## Technical Note

Project:	Adamstown		
Subject:	Aderrig Phase 2 - RFI response		
Author:	Peter Foley		
Date:	19/08/2021	Project No.:	5150924
Atkins No.:	5150924		
Distribution:	SDCC Client & Design Team

## Aderrig Phase 2

Figure 2 – Extract showing perpendicular car parking on “Avenues” in Tandy’s Lane Village

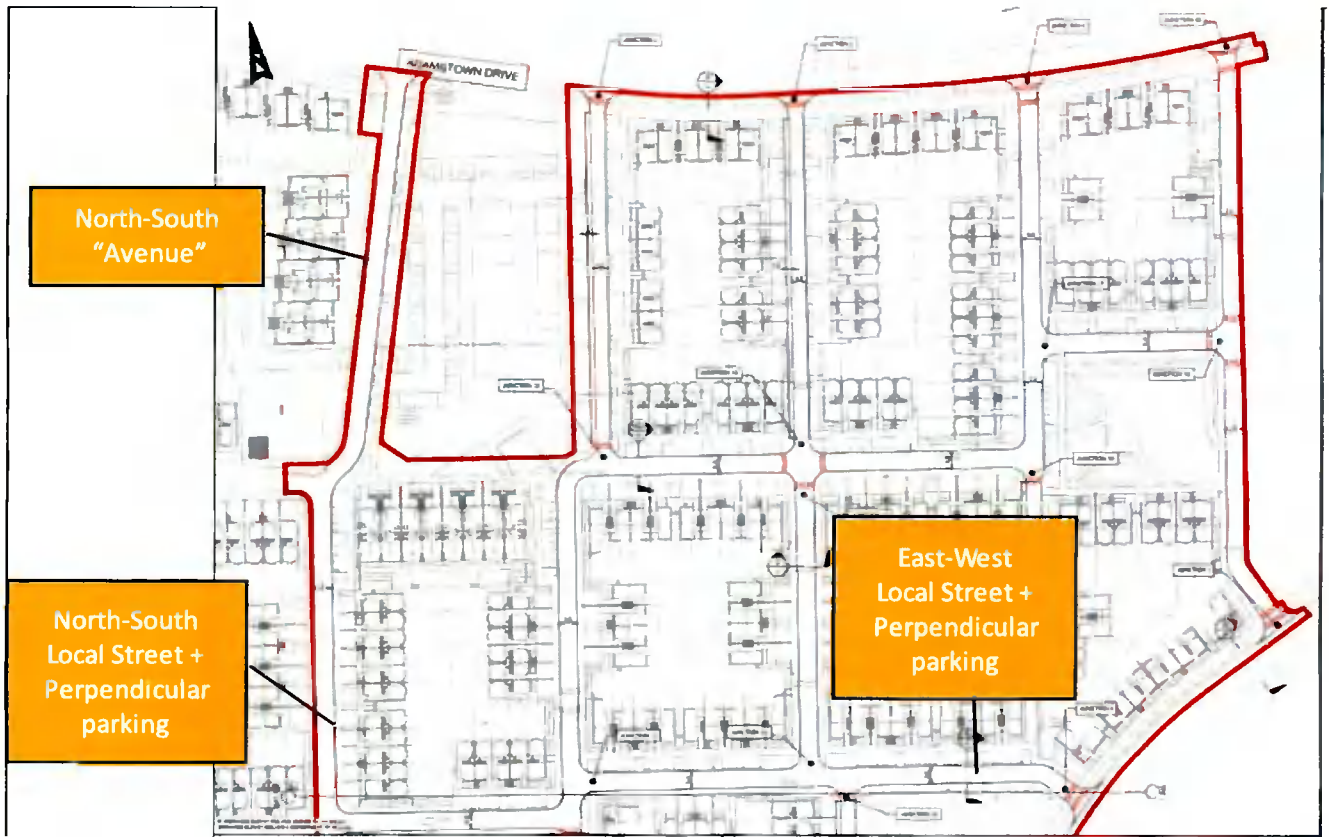
(1) The proposed 64 perpendicular in-curtilage car parking spaces located off Linear Park Road do not appear to be compliant with the Planning Scheme and the Roads Section have raised concerns in relation to traffic hazard. 'Linear Park Road' is identified in the planning scheme as an 'Avenue', the Adamstown Street Design Guide and the Planning Scheme defines as Avenue as: '...Link Streets that provide the main means of access and circulation for public transport services, pedestrians, cyclists and motor vehicles within the SDZ area. The character of these streets will be defined by higher levels of activity, particularly around local centres, nodes and places of civic importance.' Section 6.2 of the Design Guide gives clear guidance on how an Avenue should be designed and constructed. The applicant is requested to demonstrate how the proposed parking complies with the Planning Scheme and the Adamstown Street Design Guide and submit revised proposals to incorporate parallel parking provision along the eastern boundary of the subject site. The Planning Authority understands that this will significantly reduce the parking provision at this location but considers that as the proposed parking provision is at the maximum that is required there is scope to reduce car parking across the Phase 2 lands. Furthermore, there is scope to incorporate more parallel car-parking along the southern boundary at Adamstown Way, similar to the two spaces already proposed in the Parking Strategy.

Permission was granted by SDCC for Tandy's Lane Phase 1 under reference SDZ19A/0011 with street characteristics including:

Street Name	Road Dimensions	Parking Conditions
North South Avenue	6m	Perpendicular and Parallel parking
East West Avenue	5.5	Perpendicular parking

Figure 2 and 3 are extracts from the above planning drawings that show the typical conditions along the above streets.

**Figure 8 Extract showing visibility splays**

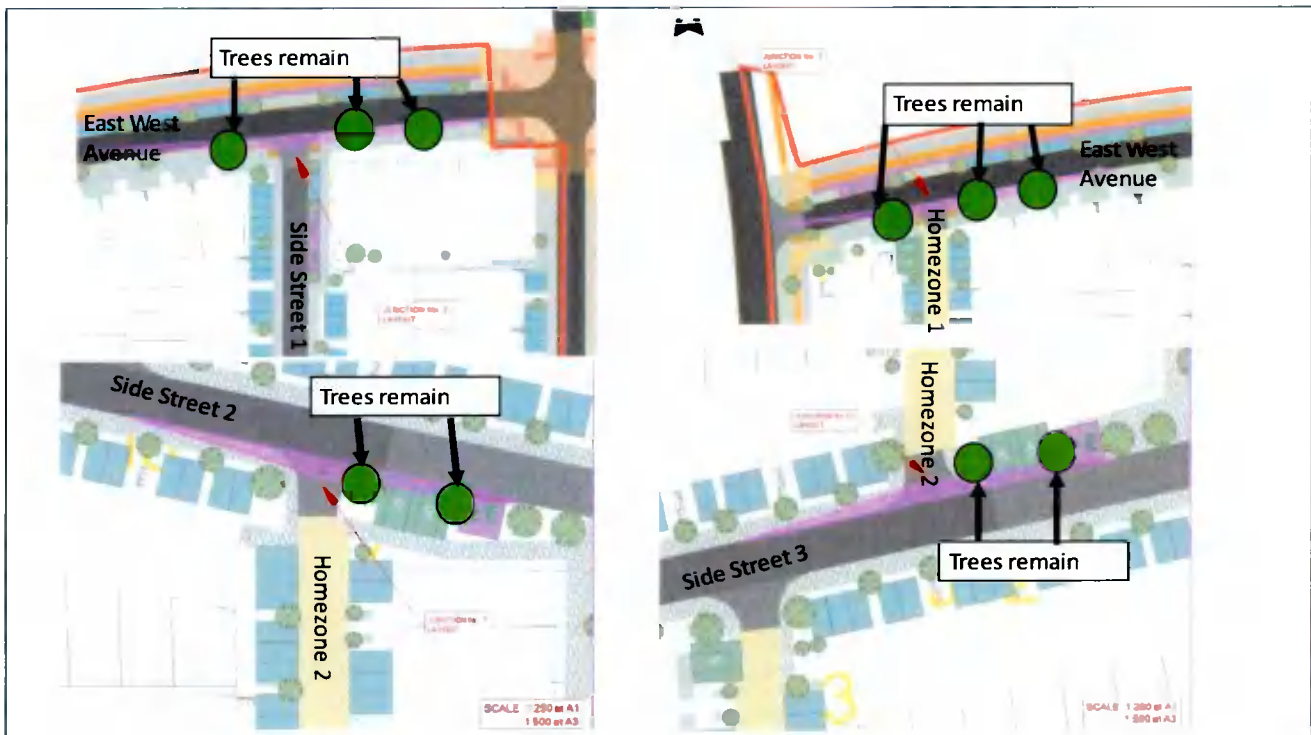
- (b) Sightlines with shown dimensions of 2.0m x 23m internally within the site and sightlines of 2.4m x 49m at the junctions with Airlie Park Road, Adamstown Way and Celbridge Link Road. Sightlines must be clear and unobstructed, and it must be demonstrated that planting or car parking will not obstruct any part of the visibility splay.

In general, sightlines are unobstructed by landscaping and/or parking. However, there are a number of locations outlined below where sightlines are slightly obstructed. Where partial obstruction of sightlines is occurring, this is a result of SDCC requirements for the provision of street trees along all roads. Examples are shown at the following junctions:

An extract from the detailed visibility drawings is shown on Figure 8.

Given that the streets have been designed as low traffic, low speed environments in compliance with DMURS principles, it is considered that the landscaping shown above do not represent a road safety risk and should be retained. However, if SDCC considers that the street trees compromise visibility splays and highway safety, then they can be removed. This of course will compromise the ability to provide street trees along this street.

Figure 11: Typical Cross Section of raised entry treatment

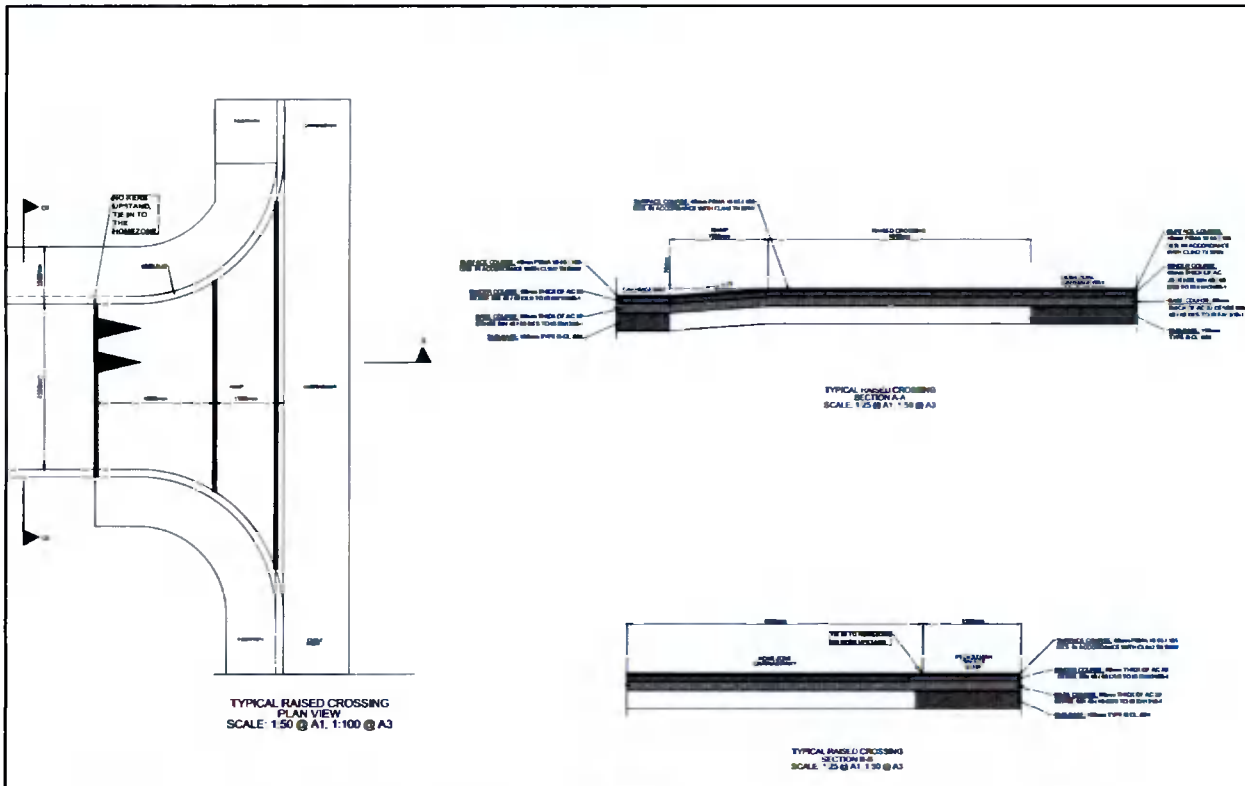
- (c) The transitions between road and homezone at (3, 6, 12 and 13) should be revised to omit the protruding kerb line at the junction which may result in vehicles over-running the corner and will result in a traffic hazard for pedestrians.

The transitions between road and homezone at has been updated to show that there is no protruding kerb line as shown in Figure 10.

The design reflects the same approach taken to the transition between home zones and side streets elsewhere across Adamstown, consisting of a raised entry treatment that ties into the homezone creating a flat surface with no kerb upstand. The drawing 5150924HTR/06/DR0116- Typical Cross Section shows this treatment in more detail. An extract of which is shown in Figure 11 below
